Department of Environmental Protection

March 10, 2006

RE: Enterprise Recycling & Disposal Class III Landfill
Pending Permit Nos.: 177982-007-SO/T3 and 177982-008-SC/T3, Pasco County

Your application for a permit is incomplete. This is the Department's second request for information. Please provide the information listed below promptly. Evaluation of your proposed project will be delayed until all requested information has been received.

FIGURE
1

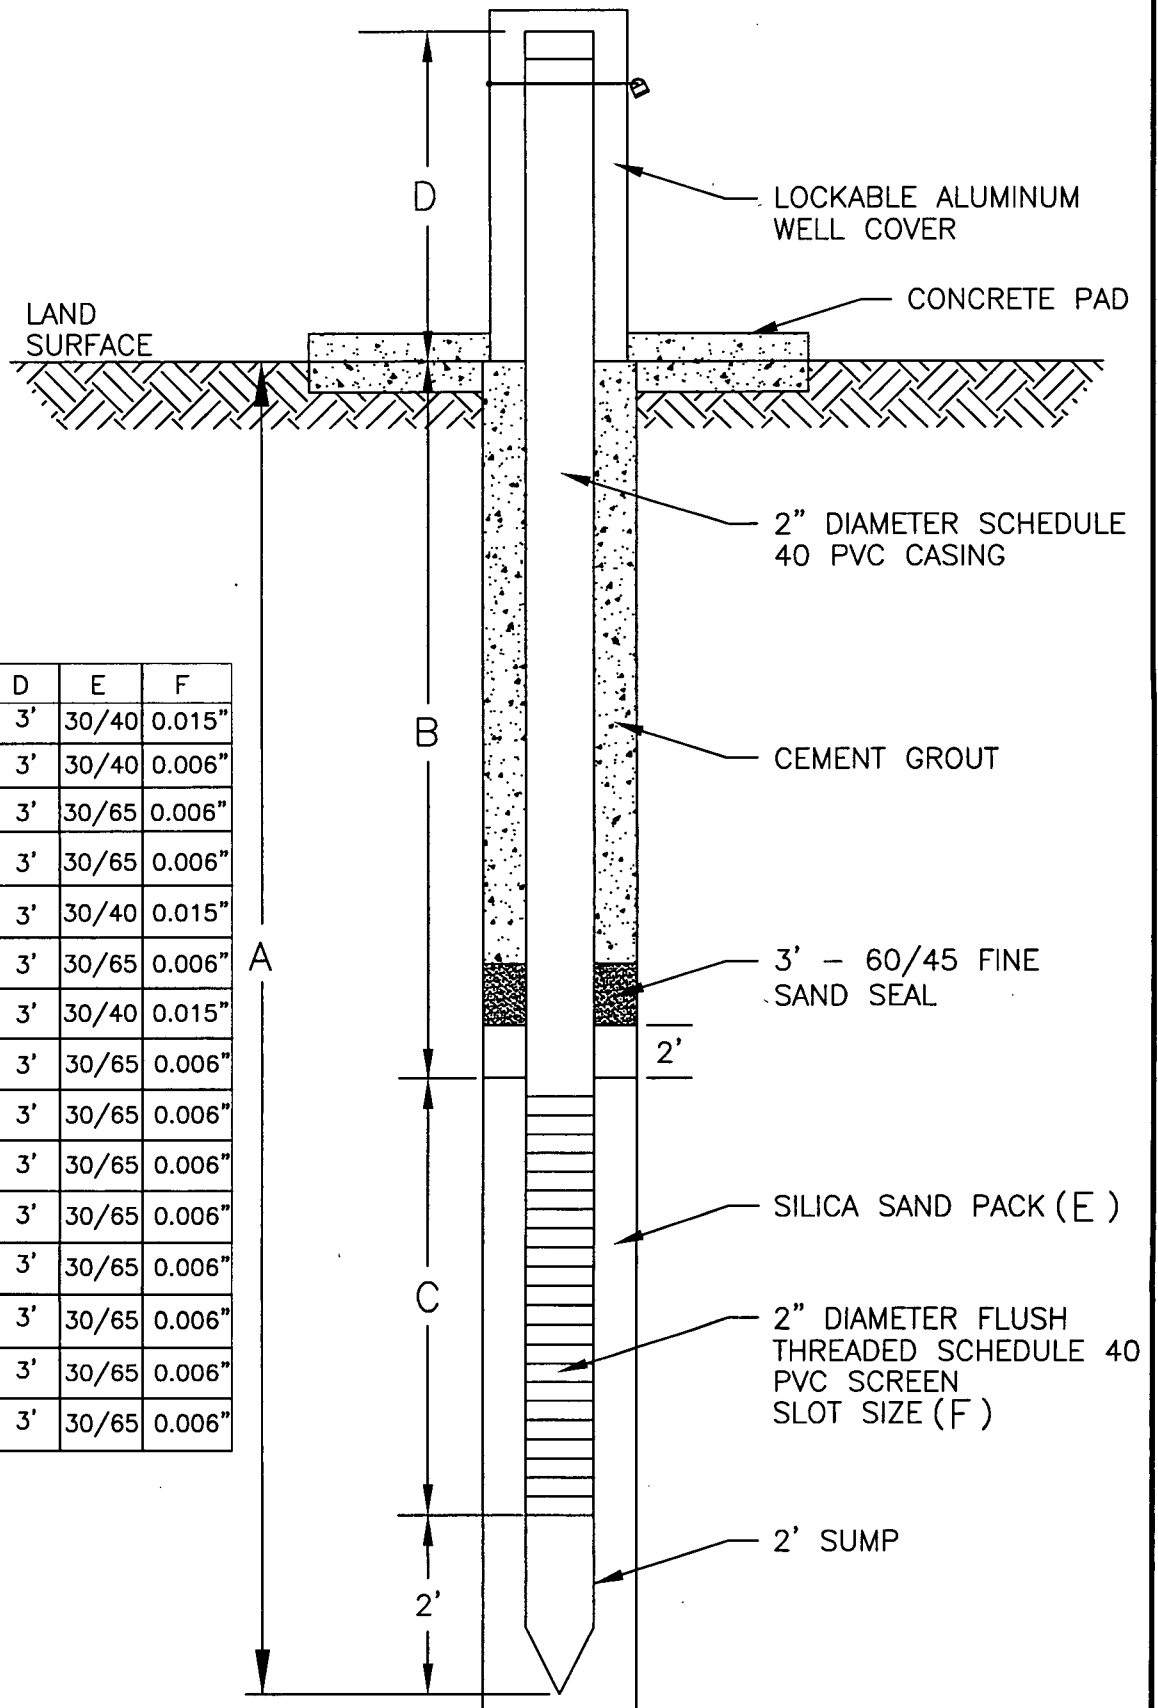
PROPOSED FLORIDAN MONITOR WELL DESIGN
 ENTERPRISE RECYCLING
 AND DISPOSAL FACILITY
 DADE CITY, FLORIDA
